Re: Permit No. M-1980-244; Cripple Creek & Victor Gold Mining Company; Cresson Project; – TR 120 Preliminary Adequacy Review Response – Process Fluid Injection Program Expansion

On January 30, 2020 Newmont Corporation – Cripple Creek and Victor Gold Mining Company (CC&V) received the Division of Reclamation, Mining and Safety (DRMS) preliminary adequacy review of Technical Revision (TR) 120, proposing an expansion of the process fluid injection program. Below are DRMS comments in italics followed by CC&V's responses in bold.

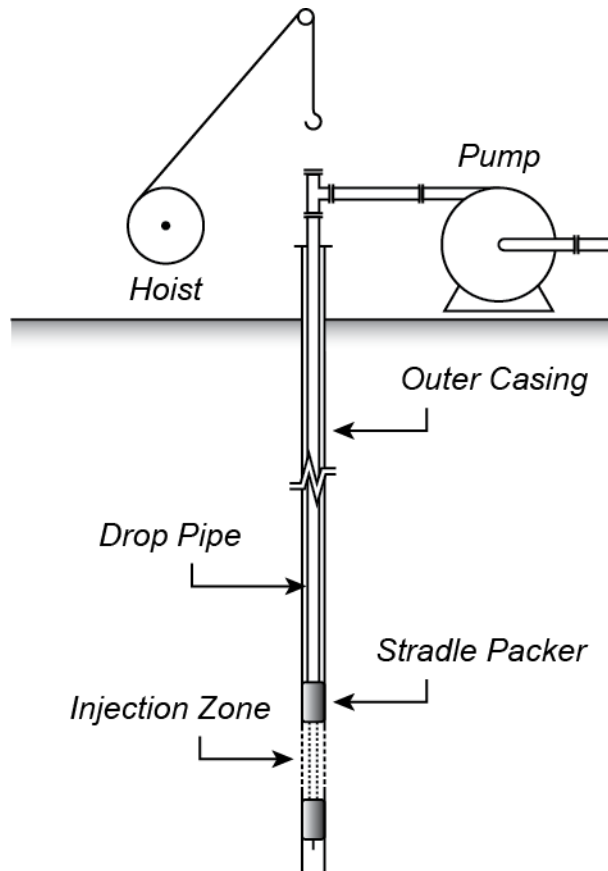
- a. *Tabular or formulaic method to estimate overburden pressure,*
Enclosed, Attachment 1 details the method to estimate overburden pressure.
- b. *Method used to control injection interval,*
Enclosed, Attachment 2 details the method used to control injection interval.
- c. *Means of monitoring slope movement (e.g., visual monitoring, instrument monitoring) and the frequency of each,*
Prism monitoring will continue on a weekly basis, measuring total vertical displacement via laser at the active injection sites.
- d. *Trigger/minimum movement, or other criteria observed that would dictate termination of fluid injection.*

The schematic in Figure 1 illustrates the basic setup required for the injection process. A straddle packer mechanism is attached to the end of the drop pipe string and positioned within the outer casing using a hoist. The drop pipe is then secured at the well head and connected to the injection pump. Solution pumped down the drop pipe passes through the upper packer and then flows into the annulus between the inner and outer casings where it is confined vertically by the inflated packers forcing it into the heap through perforations in the well bore.

Figure 1 - Schematic of injection wells installed after 2010. The 30-, 50, and 70- ft zones were not perforated as in 2010. The standard ring pattern at right was used for all injection zones. (Not to scale.)

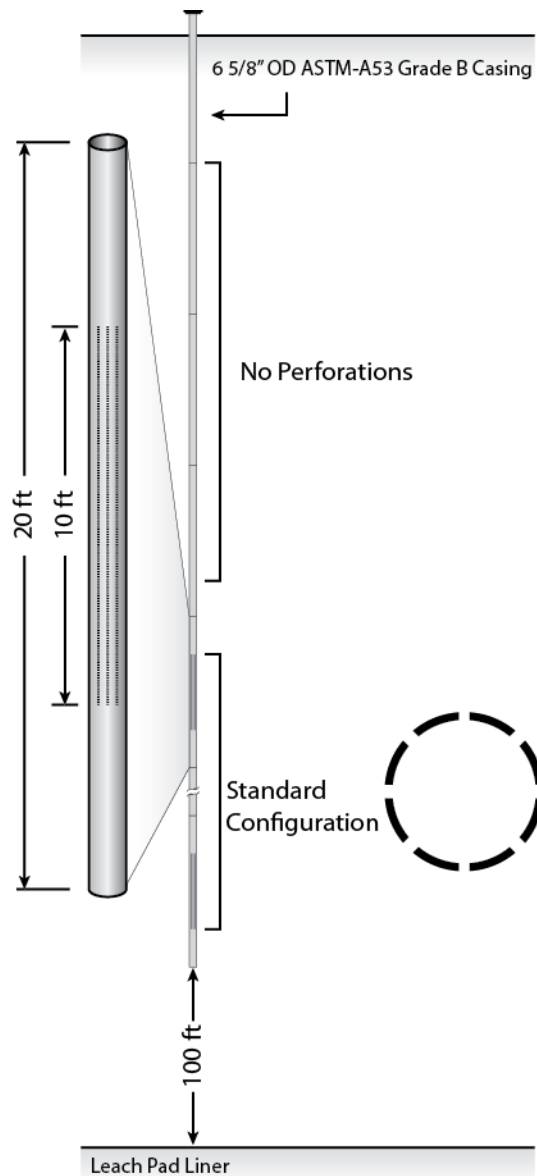
- h. *PSSA phase to which the well contributes and PSSA phase pump capacity.*
Attachment 3 details PSSA phases associated with each well.
- 3) *Well construction details:* *Please provide a typical well construction detail, or details if there are significant differences between wells, or construction logs (if available). The provided information should include perforation size and spacing, casing material and diameter.*
Enclosed, Attachment 4 describes well construction details.

Typical injection well installation on VLF 1 is shown in Figure 1

- Well spacing minimum 120 feet apart.
- A 100-foot buffer is maintained from the lowest injection zone to the bottom of the pad liner.
- A standard eight-row pattern is used for all perforations; although HJ-1 through HJ-9 had truncated perforations directed only to the center of the pad in zones 70 feet or shallower.
- The length of the perforated zones is 10 ft; although HJ-1 through HJ-9 had perforation zones of 5 ft in length.
- Injections will not be performed on zones less than 100 feet in depth from the surface.
